SERVICETEKNOTES

Tektronix Circuit Board Manufacturing Service Offered <i>(Inside front cover)</i>	AA1
New Tektronix 2225 Scope, First Member of 2200 Series to Sell for Under \$1,000	BB1
AM502 Main Board Replacement.....	1
AM503 Side Panel Shortened to Prevent Shorting to Fuse.....	1
AVC-20 OdB Gain Calibration.....	1
CG551AP/CG5001 Power-Up Errors 83 and 84.....	1
CRT Pin Cleaner Now Available	1
GMA303 Option 23 Broken CRT Neck.....	1
M/4115B/4120/P Series Power Supply Fuses F143 & F144 Change.....	2
MAG Latch Relay Retaining Screw Change.....	2
OF15X Power Supply Adjustment Improvement.....	3
PG502 Performance Check Procedure Correction (Pullout A).....	3
PG506 Standard Amplitude Specification Correction.....	3
SC501 Mod DF Description.....	3
SPG12 to SPG12A Upgrade	4
TDC1/TDC2 Oscillation Fix	4
TSG170A Power Supply Switching Transistor Failures.....	5
TSG170A False Sync Detection With No Genlock Source	5
TSG3, TSG13, TSG23 Step Linearity Out of Spec.....	6

M/4115B/4120/P SERIES POWER SUPPLY FUSES F143 AND F144 CHANGE

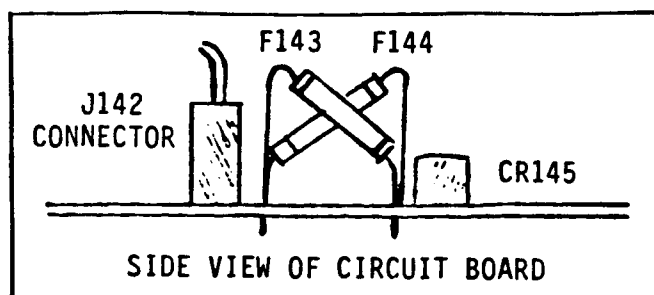
Corporate Mod 61662 has been approved to change fuses F143 and F144 on the power supply, Tektronix P/N 620-0311-0X. The fuse P/N is 159-0267-00 (2 each required), and after the mod, the power supply's P/N rolls to its next higher level.

These new fuses have a larger body than the original fuses and are rated at 2 Amps at 250 Vac, with longer blow time. These housekeeping fuses (F143 and F144) are changed because the old fuses may prematurely blow due to high

Since the 159-0267-00 fuse has a larger body, the following installation procedure should be used to prevent possible shorts.

1. After removal of the old fuses, bend one wire lead of each new fuse to form a 60 degree angle with respect to the fuse body. Bend the other lead until it's parallel to the first wire lead.
2. Insert leads in the appropriate circuit board holes and dress one fuse to slant above circuit board toward the left and the other fuse toward the right (refer to drawing).
3. Solder and trim as necessary.
4. Do not allow the metal parts of the fuses to touch anything except where the leads are soldered into the circuit board.

1360P INSULATOR SLEEVE WRONG P/N CORRECTION

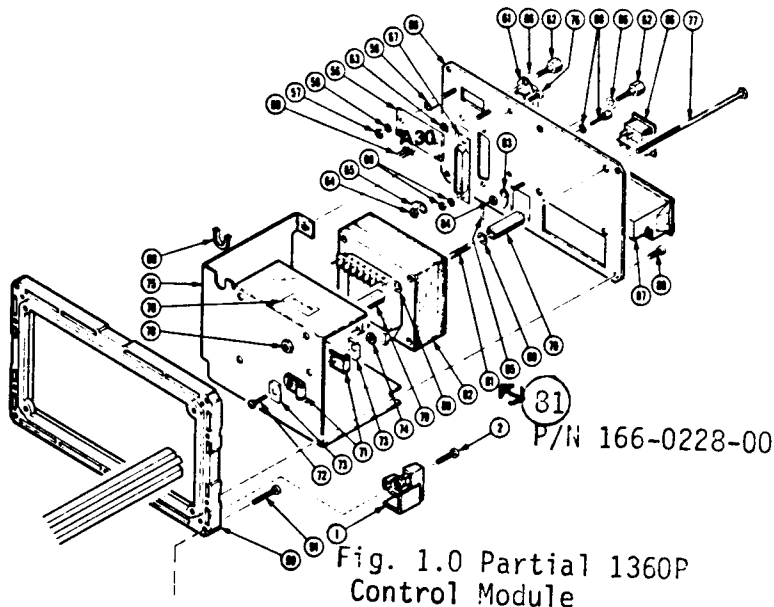
Figure 1.0 is a partial mechanical exploded view of the 1360P Control Module. The correct Tek P/N for index #81 is 166-0228-00 as indicated.

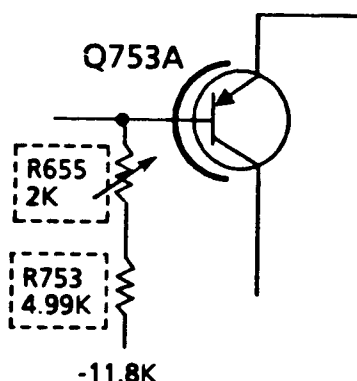
Item 2 was addressed by changing A3R753 from 6.19K ohms to 4.99K ohms and by adding A3R655, "teepee" fashion, in series with R753 and the base of Q753A (see drawing below).

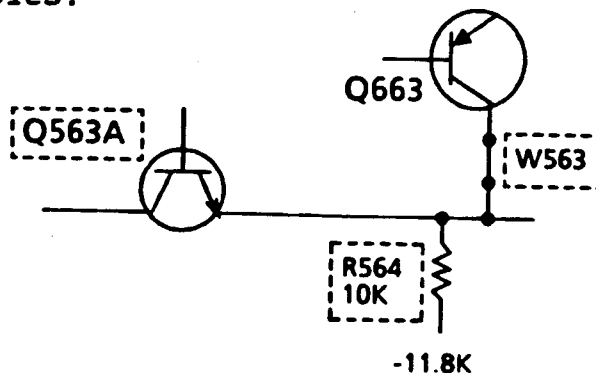
Item 4 was addressed by replacing A3C564 with a 0 ohm resistor (P/N 131-0566-00), reversing Q563, and adding A3R564, a 10K ohm resistor (P/N 315-0103-00) from the emitter of Q563 to an 11.8 volt source (located at the left leg of A3R568). (See drawing below) Q563 can be most easily installed by inverting it and routing the leads to the appropriate holes.
